**AIRWORTHINESS
DIRECTIVE**

NUMBER:
02 / 09

AFFECTED PRODUCTS: Amateur built aircraft (Order 31 May 1982, BOE 5 June) constructed from kits PEGASUS QUIK all versions, and any other aeroplane (home built or Type Certificate) fitted with CKT stainless steel twin exhausts, which have serial numbers 8230 to 8430.

SERVICE BULLETIN NUMBER 127
including
MODIFICATION M228

Fig 3 Exhaust Keeper modification M228

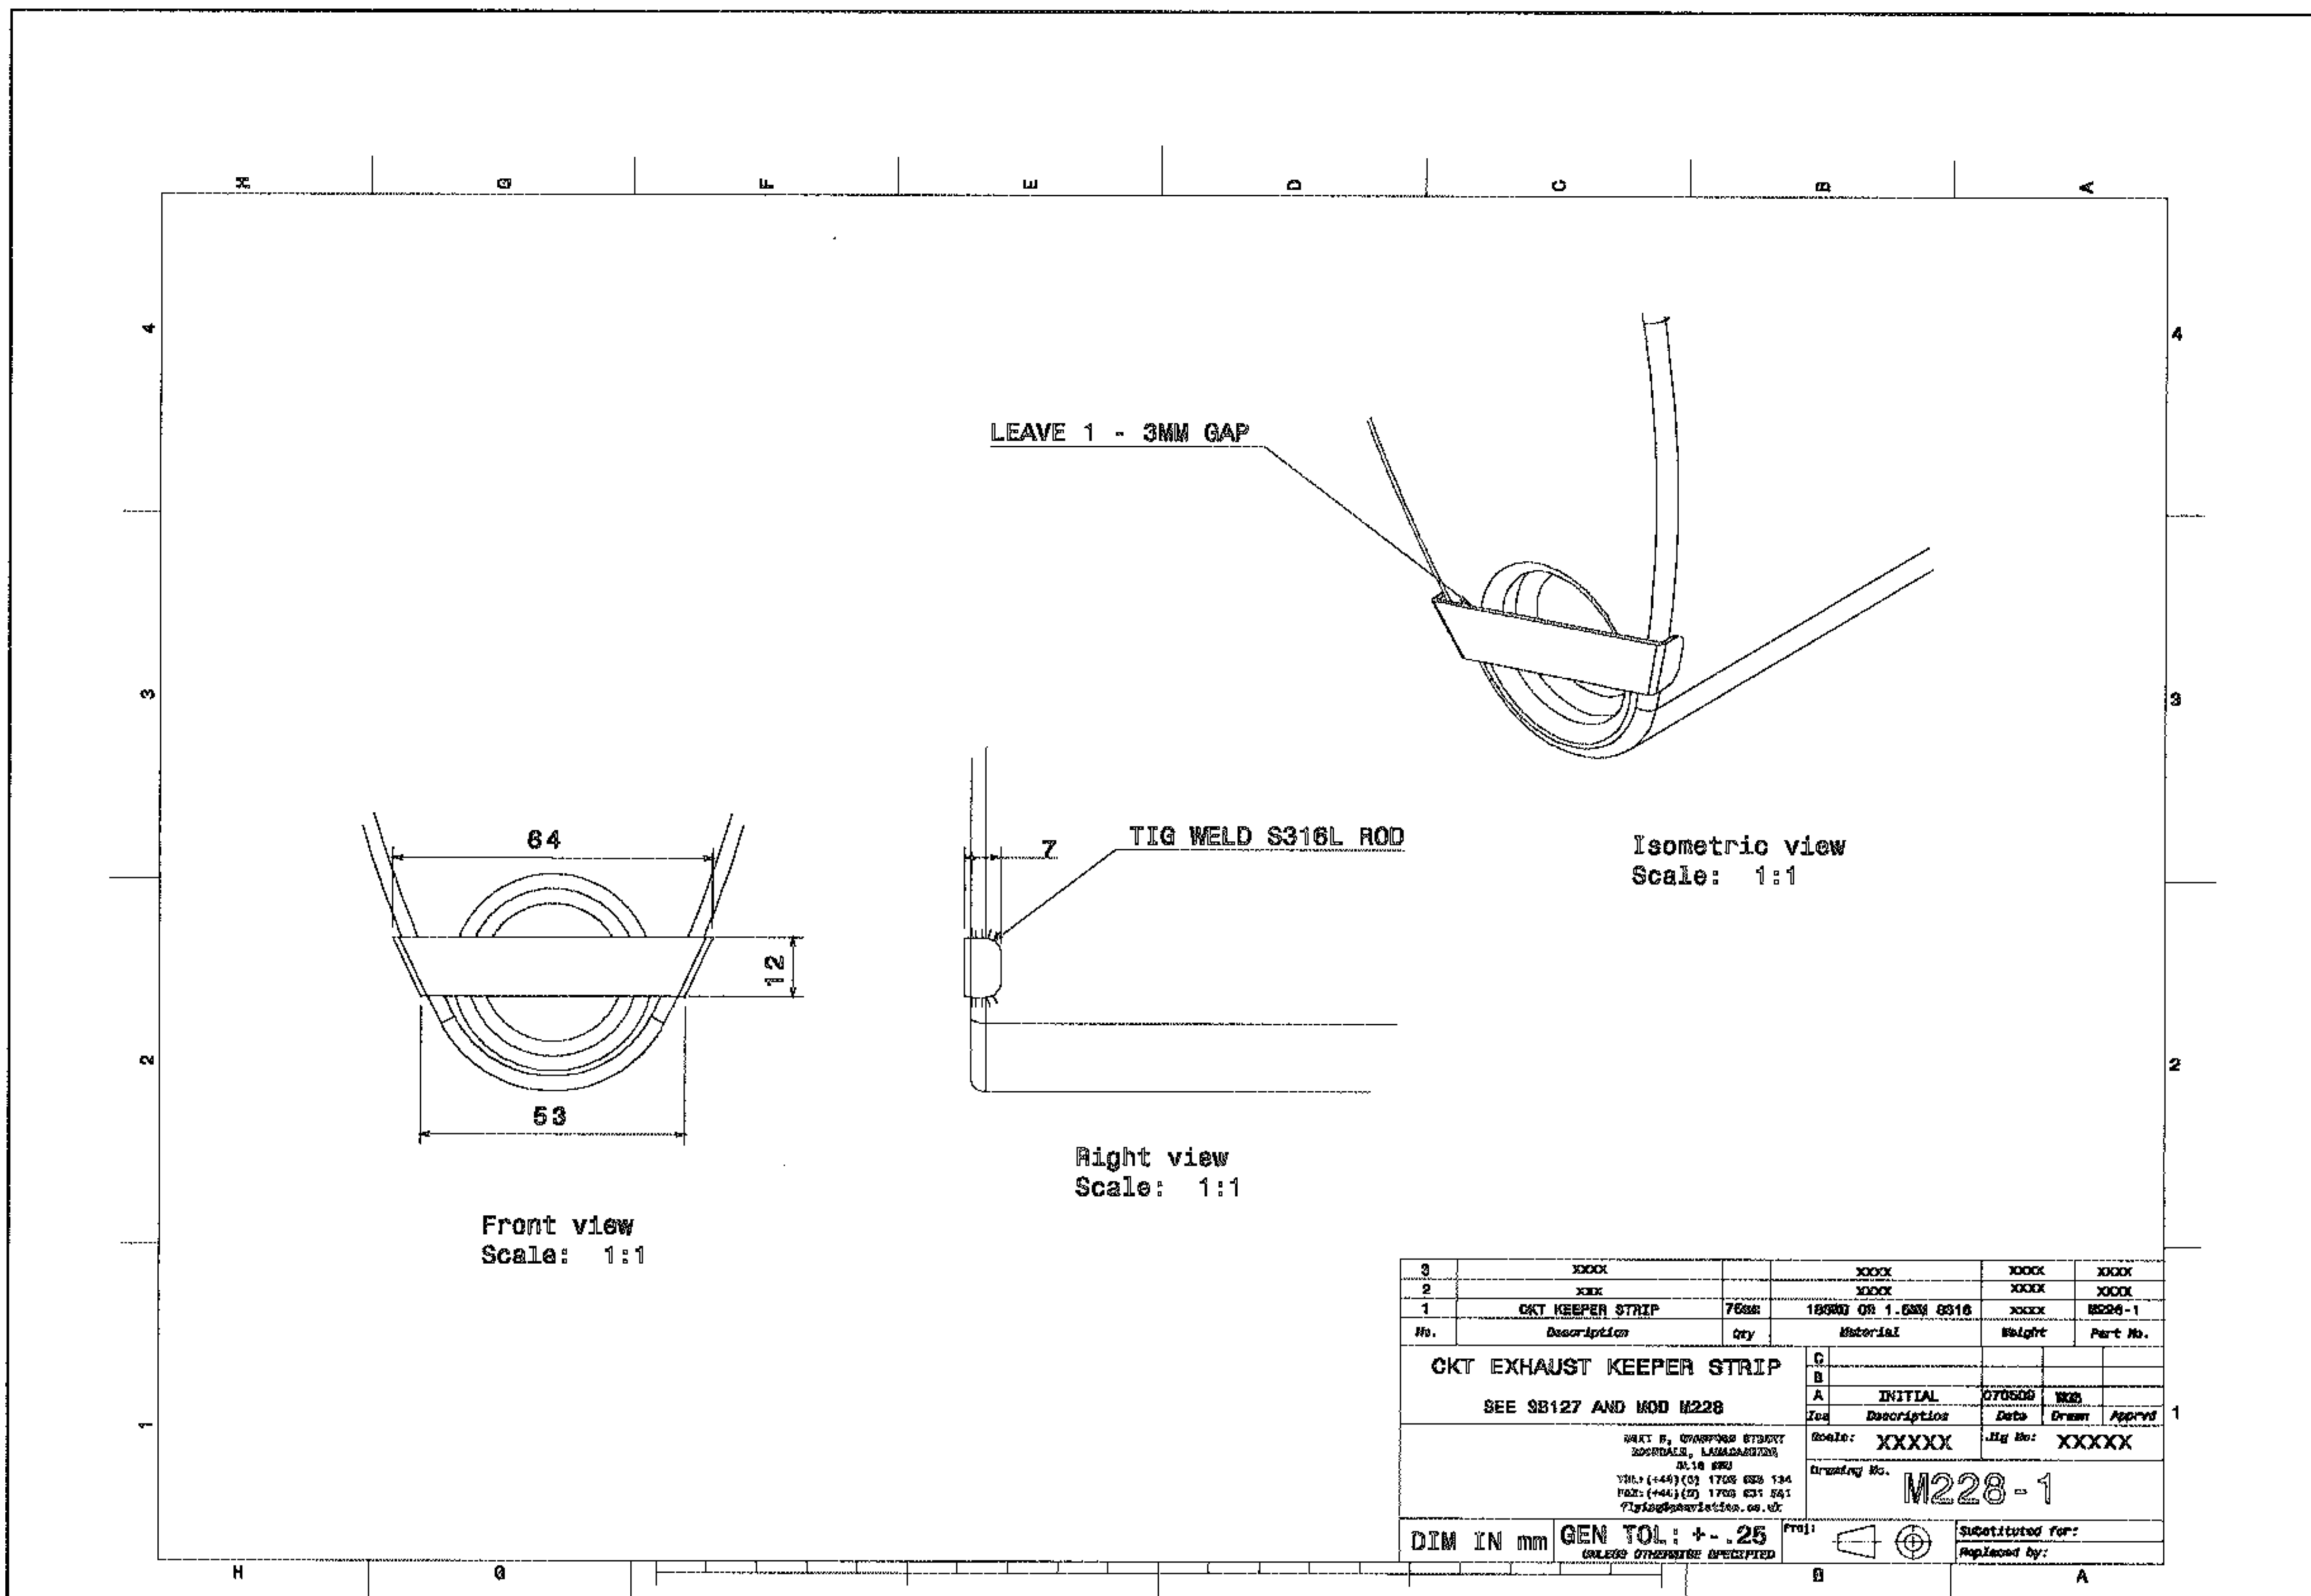
If the inner ends of the baffle tubes and internal baffles are secure, modification M228 can be carried out (see fig. 3). It provides a backup retainer if the baffle should become loose. Thoroughly clean the area. Do not use any dissimilar wire brush metals and do not mark with graphite or carbon pencils. Weld repair any cracks found using a stainless steel 316L welding rod and TIG process. Fit a 12mm wide x 18swg (1.22mm) or 1.5mm S316 strip with 7mm bent edges as shown, weld to the silencer ONLY at the corners, over the existing corner weld. The repair/modification must be carried out by an aviation approved welder qualified for thin (0.9mm) stainless steel. FAA publication AC43-13-1B is a useful guide to procedures.

Fig 4 Exhaust springs and backup cable

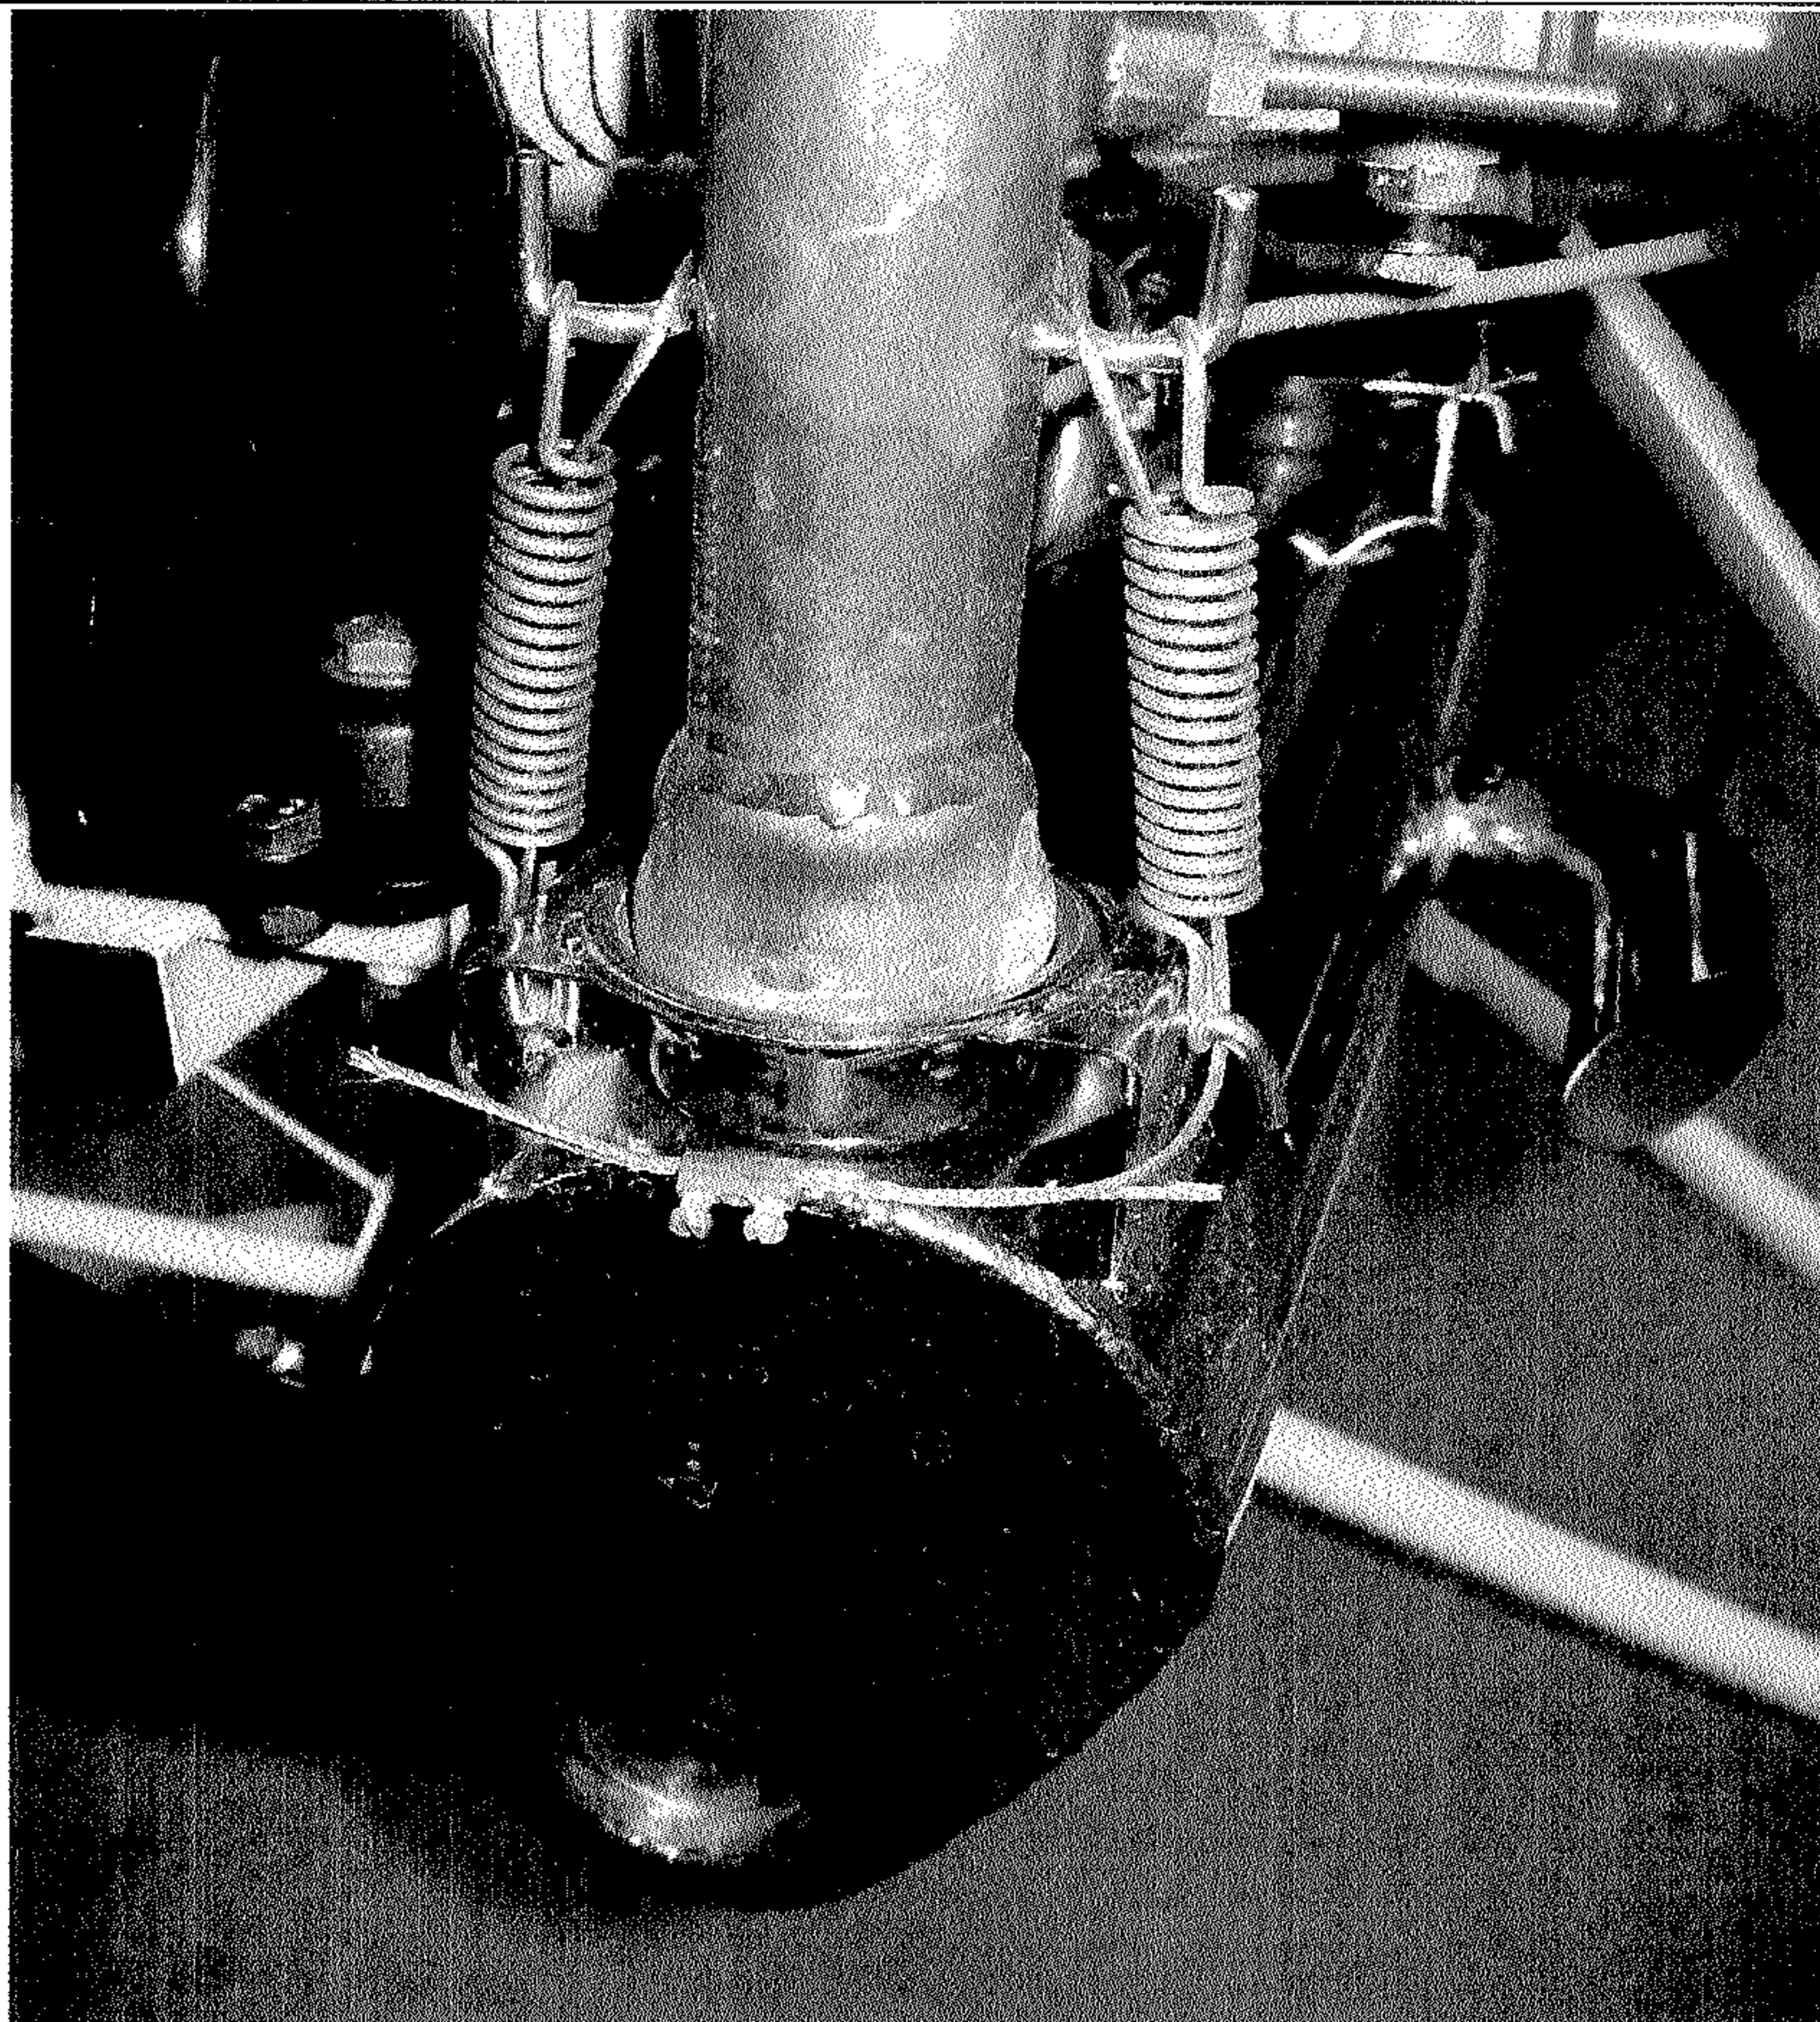
- d) Apply Copaslip or similar high temperature anti-seize compound to the ball joints
- e) Refit the springs, using a cord to fit them. Rocking the can relative to the pipes may help.
- f) Refit the anti-vibration mount using 20mm washer under a new nyloc nut. Avoid twisting the rubber mount.
- g) Refit the backup cables through the springs as shown in fig 4.
